Dekko Designs Ltd. (New Building)

Purba Naroshinapur, Ashulia, Savar, Dhaka
(23.927480N, 90.304272E)
25th August 2016

SOUTH SIDE ELEVATION

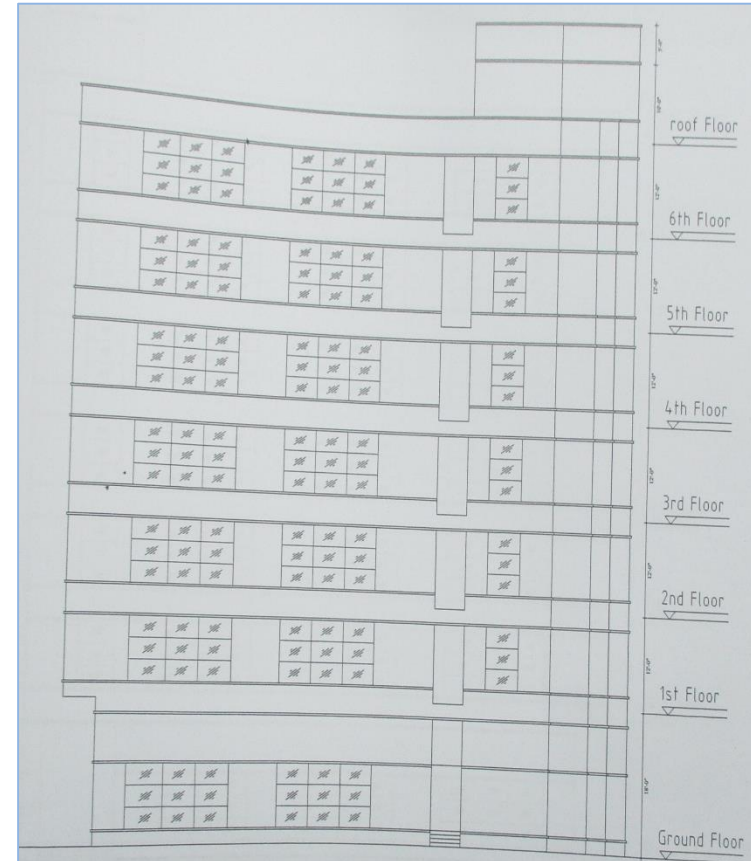
Connecting bridge location having mismatch between drawing and site condition

Actual bridge position

According to drawing bridge position

Roof plan missing and North-South elevation doesn't reflect as built condition.

Item No.	Observation	Recommended Action Plan	Recommended Timeline
1	Discrepancies in Architectural and Structural drawing	Engage a Building Engineer to survey the structure and update a full set of “as-constructed” drawings for Structural and Architectural.	6-weeks
2	Damage to underside of beams and visible reinforcement at locations of cast-in electrical conduits.	Building Engineer to carry out survey to identify locations where structural capacity of reinforced concrete beams has been reduced by penetrations or electrical conduit installation.	6-weeks
3	Damage to underside of beams and visible reinforcement at locations of cast-in electrical conduits.	Building Engineer to carry out design calculations to verify the adequacy of the structure and to prepare a schedule of remedial works to reinstate the areas affected by the electrical installation.	6-months
4	Lack of protection on around lift core.	Provide protection to ensure safe working passage.	Immediate - Now

Lack of protection on around lift core

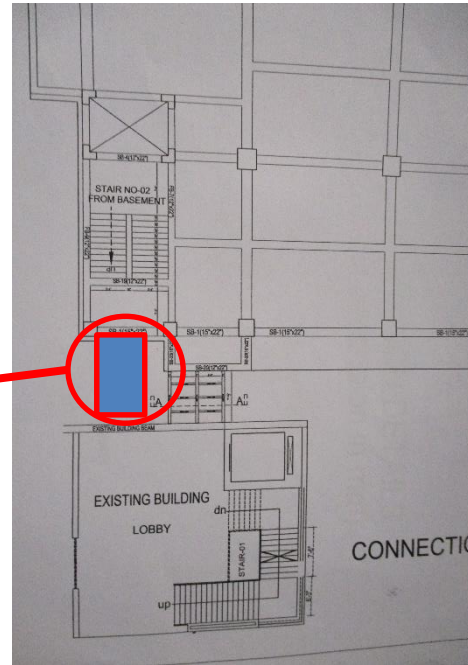
Lack of edge protection around the lift core near stair areas to caused falling hazards.
